Product Change Notification / GBNG-01CETU513

CCB 4427 Initial Notice: Qualification of NSEB as a new assembly site for selected Atmel ATXMEGA device family available in 64L (9x9x1mm) VQFN package.

PRE AND POST CHANGE SUMMARY

PCN #: GBNG-01CETU513

Pre Change

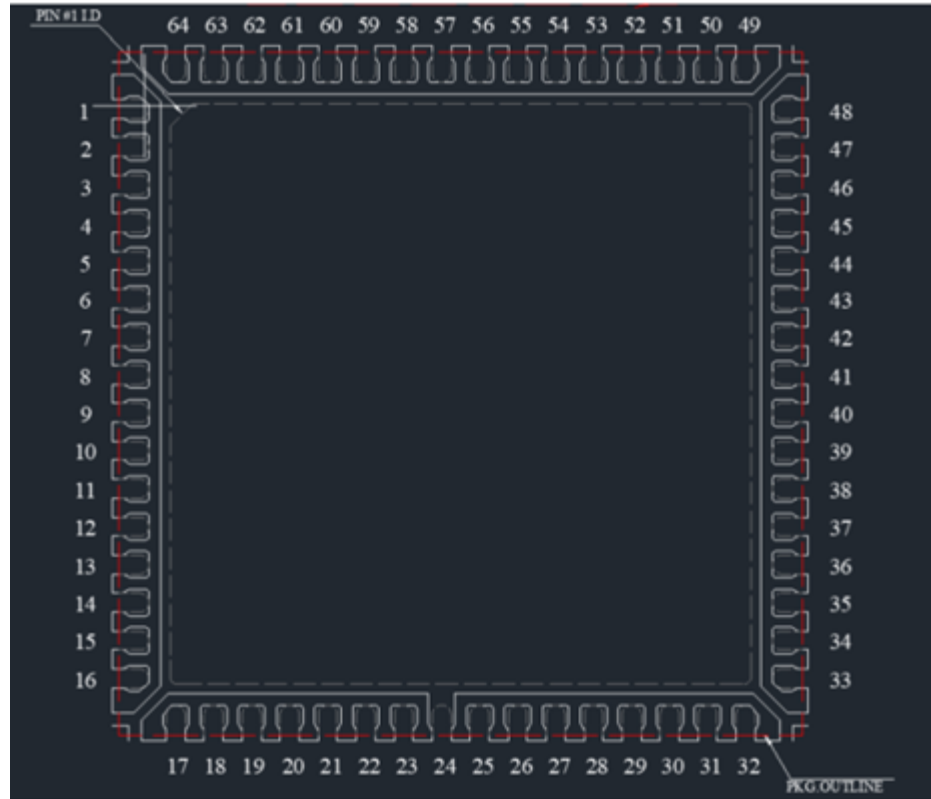
Lead-lock

No

Post Change

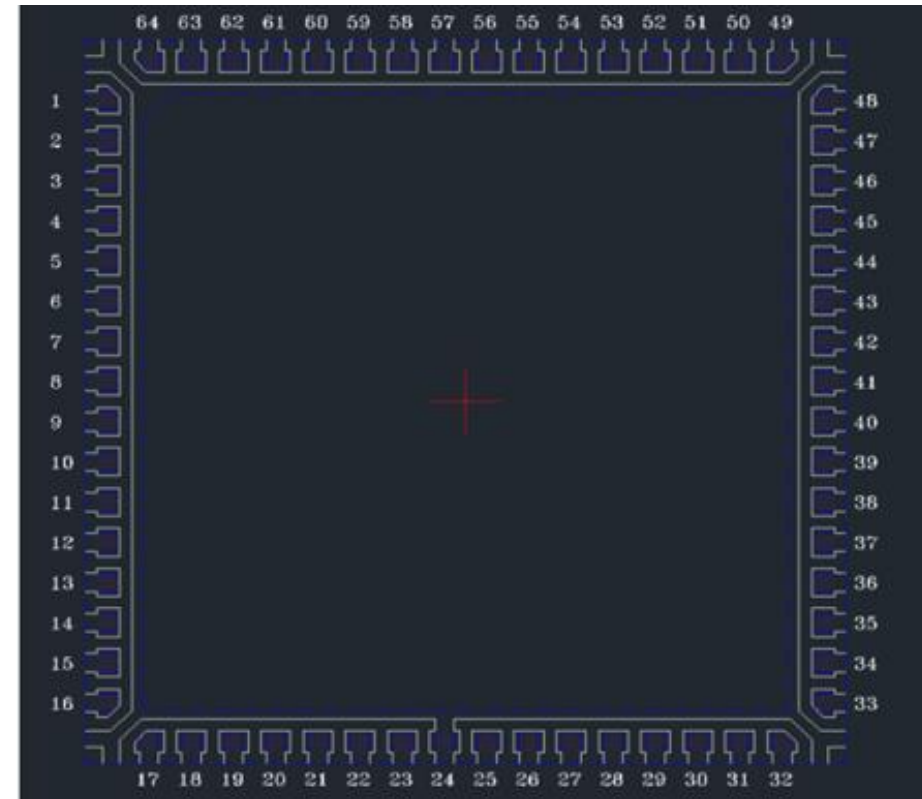
Lead-lock

Yes
